AMENDMENT NO. 1 NOVEMBER 1978
TO
IS : 5991-1971 SPECIFICATION FOR
BALLAST RAKES

Addendum

FIG. 2 LOAD TEST OF BALLAST RAKE

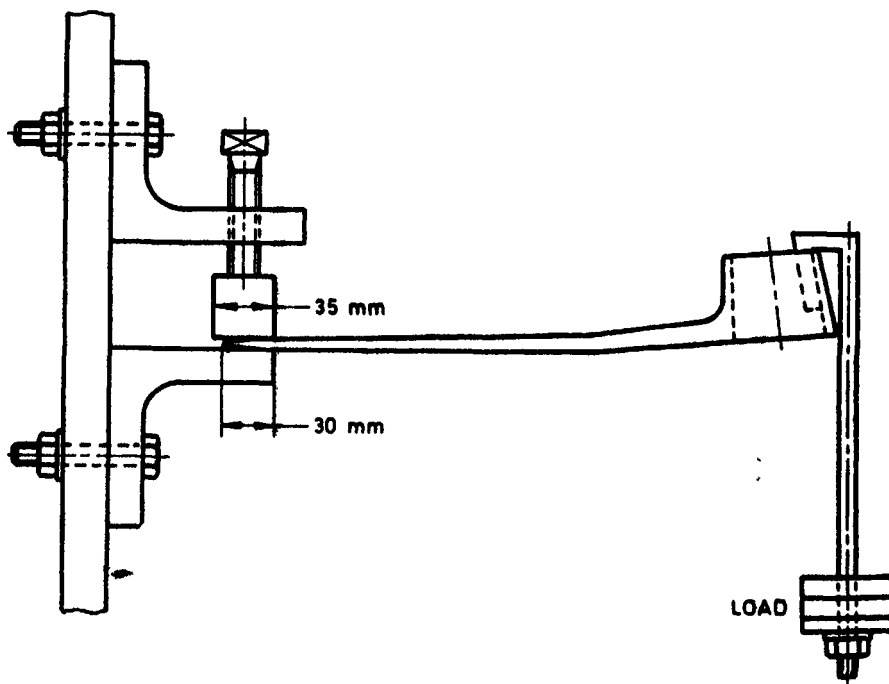
(Page 5, clause 11.1) — Add the following new matter after 11.1:

'11.2 Load Test — The ballast rakes shall be subjected to load test as shown in Fig. 2. The load test shall be carried with 50-kg load and the ballast rakes shall not show any permanent set after removing the load.'
